SUBJECT: ISSUANCE OF AMENDMENTS (TAC NOS. M82712 AND M82713)

The Commission has issued the enclosed Amendment No. 83 to Facility Operating License No. NPF-11 and Amendment No. 67 to Facility Operating License No. NPF-18 for the LaSalle County Station, Units 1 and 2, respectively. The amendments are in response to your application dated January 21, 1992.

The amendments add new setpoint requirements to Section 4.9.6 of the Technical Specifications (TS) for the main refueling mast. The setpoints are for the fuel hoist loaded and the overload cutoff interlocks and are required due to the station's plan to install a new mast of a slightly different design.

SAFETY EVALUATION BY THE OFFICE OF NUCLEAR REACTOR REGULATION
RELATED TO AMENDMENT NO. 83 TO FACILITY OPERATING LICENSE NO. NPF-11 AND
AMENDMENT NO. 67 TO FACILITY OPERATING LICENSE NO. NPF-18
COMMONWEALTH EDISON COMPANY
LASALLE COUNTY STATION, UNITS 1 AND 2
DOCKET NOS. 50-373 AND 50-374

Figure 1

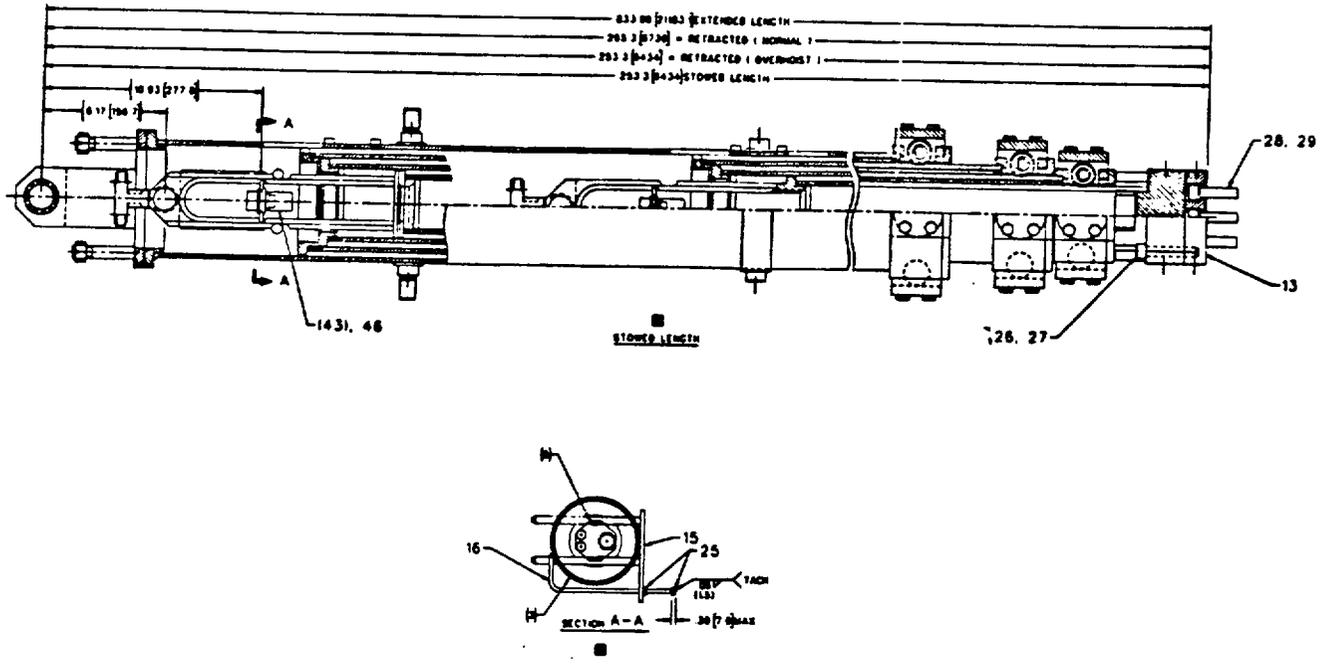
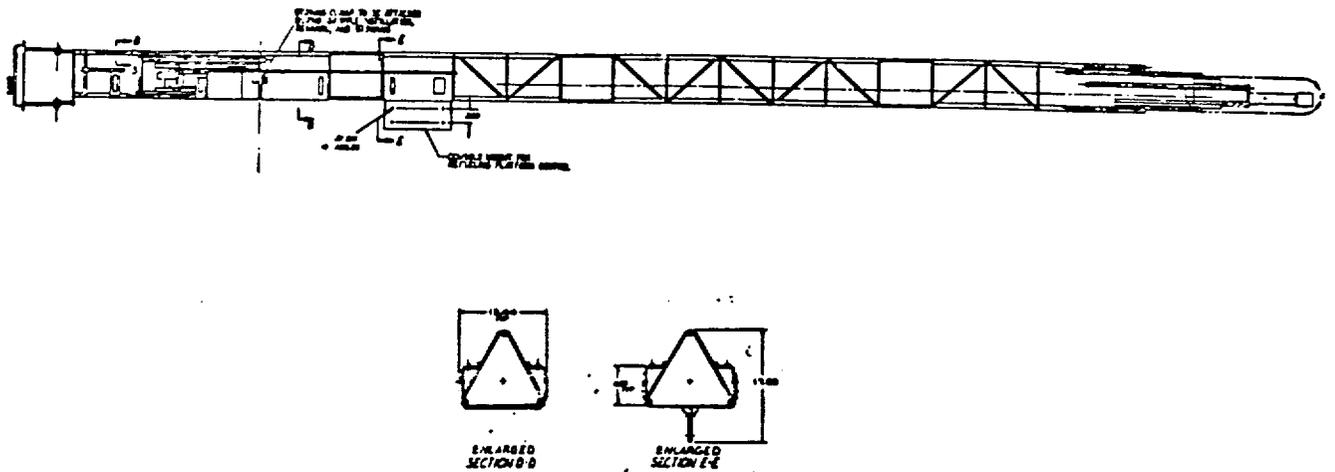
The new refuel mast (NF500) design consists of four concentric, telescoping, solid tube sections (see Figure 1). The mast hangs down vertically from the bottom of the trolley. The top section is fixed to the trolley and does not move in the vertical direction. When the hoist is in the "normal up" position, only the weight of the top section of the refuel mast is transmitted directly to the trolley. The weight of the three lower sections, plus any load on the grapple, is supported by the hoist via the hoist cables. When the hoist is in the "normal down" position, only the weight of the lowest section of the mast, plus any load on the grapple, is supported by the hoist. The other sections of the mast are directly supported by the section above it, and therefore, by the trolley. Since the main fuel hoist is located on the trolley, the total weight of the mast and any load on it is, at all times,

The existing refuel mast design (762E974) consists of four concentric, triangular, telescoping sections. Each section is constructed of reinforced tubular frame in a lattice work arrangement (see Figure 2). The way the mast operates and transmits the load weight to the crane support structure is similar to the new mast. The main difference is that the existing mast is 420 pounds lighter than the new mast. The weight differential is due primarily to its open lattice construction vice the solid construction of the new mast.

The licensee proposes to modify the requirements in Section 4.9.6 of the TS for the Overload Cutoff and the Fuel Hoist Loaded interlock setpoints. The existing requirements for the 762E974 mast would remain, but would be clarified to show that they were for that mast only. New requirements would be added for the NF500 mast which would require different setpoints because of its heavier weight. The new setpoints proposed by the licensee are 1600 +100/-0 pounds for the Overload Cutoff setpoint and 700 +50/-0 pounds for the Fuel Hoist Loaded interlock setpoint.

- a. Demonstrating operation of the overload cutoff when the load exceeds:
 1. For the fuel hoist:
 - a) 1600 +100/-0 pounds with the NF500 mast.
 - b) 1200 +50 pounds with the 762E974 mast.
 2. 1000 ± 50 pounds for the auxiliary hoist.
- b. Demonstrating operation of the loaded interlock when the load exceeds:
 1. For the fuel hoist:
 - a) 700 +50/-0 pounds with the NF500 mast.
 - b) 485 +50 pounds and 550 +50 pounds with the 762E974 mast.
 2. 400 ± 50 pounds for the auxiliary hoist.
- c. Demonstrating operation of the fuel hoist downtravel stop when downtravel exceeds 54 feet below the platform rails.
- d. Demonstrating operation of the fuel hoist and auxiliary hoist up-travel stops when the grapple is lower than or equal to 8 feet below the platform rails.
- e. Demonstrating operation of the fuel hoist slack cable cutoff when the hoist is unloaded.
